Killowen, Kenmare, Co. Kerry

Proposed Large Residential Development

Stage 1 Road Safety Audit

Client	KPH Construction
Project Title	Proposed LRD Killowen, Kenmare, Co. Kerry
Document Title	Report for Stage 1 – Road Safety Audit
Job No.	25067TT
Document No.	25067TT-Doc01

Fig 2.2

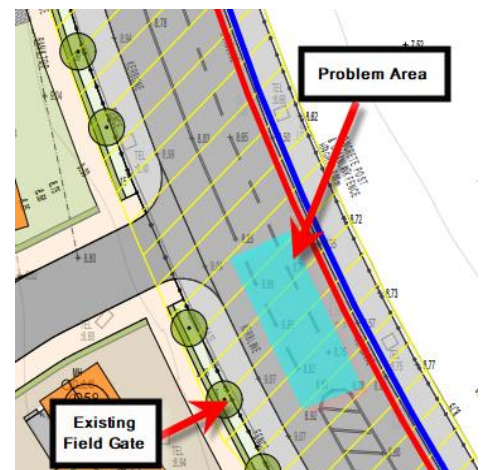
2.3. PROBLEM: EXISTING ROAD MARKING ON PAT SCARTEEN RD

The site layout issued to the audit team, shows that the proposed junction will be approximately 10m to the north of the existing field gate entrance. The existing road markings and subsequent right turn lane on Pat Scardeen Rd was laid out to accommodate this field gate position. If the existing road markings are retained when the development is operational, this could lead to confusion for the road users and head on type collisions between vehicles travelling along Pat Scardeen Rd.

Recommendation 3

The design team should ensure that the road markings on Pat Scardeen Rd at the proposed entrance are designed in accordance with relevant standards.

To be completed by the Designer			To be Completed by Audit Team Leader
Paragraph No. in Safety Audit Report	Problem accepted (yes/no)	Recommended measure accepted (yes/no)	Describe alternative measure(s). Give reasons for not accepting recommended measure. Only complete if recommended measure is not accepted	Alternative measures or reasons accepted by auditors (yes/no)
2.1	Yes	Yes		
2.2	Yes	Yes		
2.3	Yes	Yes		
2.4	Yes	Yes

Fig 2.3

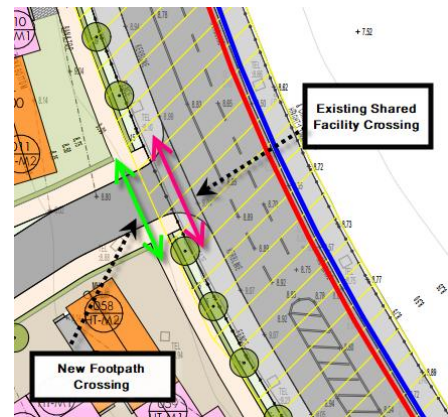
2.4. PROBLEM: VULNERABLE ROAD USER CROSSING FACILITY AT THE DEVELOPMENT ENTRANCE

The site layout shows two separate crossing facilities at the proposed development entrance. This includes the existing shared facility on Pat Scarteen Rd and the a new internal footpath crossing. Multiple crossing points at this location could lead confusion for all road users and to potential pedestrian/vehicle type collisions.

Recommendation 4

The design team to provide a revised junction layout incorporating a crossing facility designed in accordance with relevant standards.
